TSB # 323-0059  
Prince Castle  
355 East Kehoe Blvd  
Carol Stream, IL 60188  
Date 1/22/2018

In a going effort to ensure quality on our Genuine OEM Equipment we are Issuing a Technical Service Bulletin for our DCFT Toaster Series. This bulletin will cover the retrofit of the new DCFT Club Idler Pulley Assembly (OEM Part # 527-888s) that will be replacing discontinued Pulley Assembly (OEM Part # 527-818s) listed below. Please see detailed instructions below.

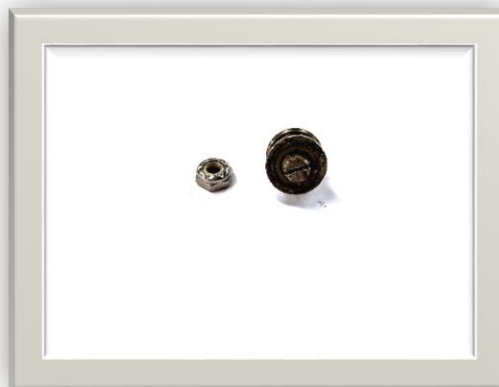
Old rev Idler Pulleys could have reduced life span causing damage to the club drive belt. This could lead to the club section unable to rotate.

- Club Drive Belt Has Reduced Life Span
- Club Section Does not rotate

- 527-888s (Club Drive Idler Pulley – Assembly)

- 527-818s (Club Driver Idler Pulley – Assembly)
